Technical change to MultiCard in red

- PCN-number : PCN-PKD80-20200512-00-A
- Date of publishing : 13.05.2020
- Duration of validity : unlimited
- Revision number : none

Old and new version are visually identical -> Examples

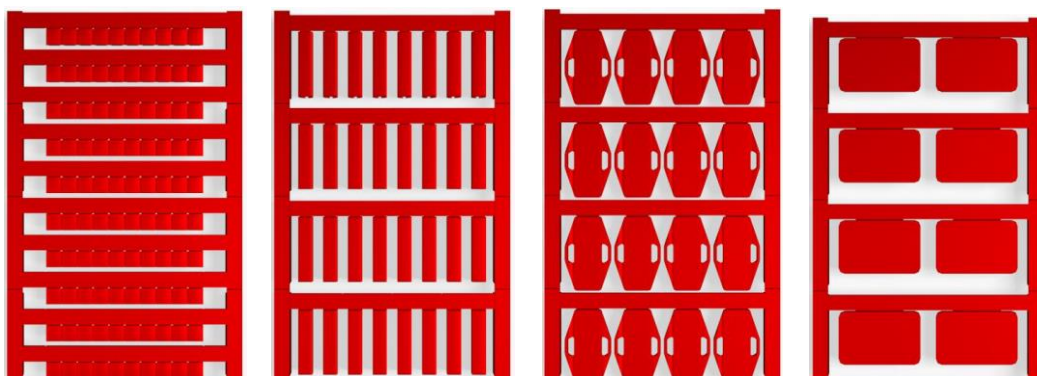
From now on we use only full colored polyamide PA66, so that a mixture is no longer needed.

- The function and printability of these markers are not affected.
- The color tone red does not change.
- Small deviations of up to 1mm are possible over the entire card length. This can easily be adjusted by the labelling software M-Print Pro.
